RFI No	Affected Bid Package	Reference Document Name	Page / Section	Question	Response
1	10C - Division 10 Specialties	Bid Manual	Equipment List	Is the paper Towel Dispenser noted in the biology lab 215 supposed to be CFCI? All other paper towel dispensers are OFOI. If CFCI, provide manufacturer information to purchase/install.	Paper towel dispensers in Biology Lab to be OFOI. The equipment list has been updated.
2	10C - Division 10 Specialties	Bid Manual	Equipment List	In room 367, the equipment list notes a patient lift - ceiling. Please provide specific product for both the track and lift. Confirm fully installed fixed system. What accessories are to be included? Are the accessories to be included as add alternates or base bid?	Provide Arjo KWIKtrak with Maxi Sky 2 lift in base bid. Any additional accessories by owner. The equipment list has been updated.
3	10C - Division 10 Specialties	Bid Manual	Equipment List	There are two items shown in the list for building HB. Please confirm that these are not to be included in this package as no work is shown to occur in HB. If they are only to be relocated, please update to OFCI and note where they should be relocated to.	These items are t

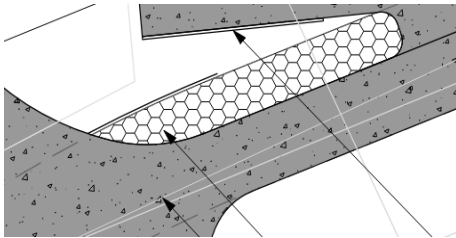
56	32B Landscaping & Hardscapes 32C - Site Concrete	Drawings	L132	<p>Sheet L132. Per the following screenshot, can we assume the edge shown will continue all the way across, from left to right, at the Grasspave?</p> 	Correct. The concrete curb at the edge of the Grasspave shall extend the full length of the GrassPave. Concrete curb to be installed by 32C - Site Concrete bid package.
57	32B Landscaping & Hardscapes	Drawings	L132	Sheet L132. Will the trench drain (D1/L504) be by others?	Yes. The trench drain will be supplied by 22A - Plumbing and installed by 32A Sitework.
58	32B Landscaping & Hardscapes	Bid Manual	Schedule A	<p>#87: Reuse stockpiled topsoil where shown. Please confirm the stockpile location.</p> <ul style="list-style-type: none"> - Will the topsoil be screened by others? - Can we assume there is enough topsoil to satisfy the depths required per the specs and per the areas shown per Sheets L181 and L182? - If there isn't sufficient topsoil in the stockpile, we will need to know, via an allowance, how much to import. - If there is too much stockpiled soil, who's responsibility is it to dispose of the soil? Will it be disposed of on or off site? 	<ul style="list-style-type: none"> - Topsoil will be stockpiled onsite, at a location to be determined by the Brasfield & Gorrie superintendent. - Topsoil will be screened and spread by the bid package 32B Landscaping & Hardscapes - Assume there is enough topsoil to stockpile (by 32A - Sitework) what is required for landscaping needs. Bid package 32B - Landscaping & Hardscaping to coordinate the exact amount that will be required. - If there is extra topsoil, it will exported by 32B - Landscaping & Hardscaping (coordinate amount with site contractor to have no extra).
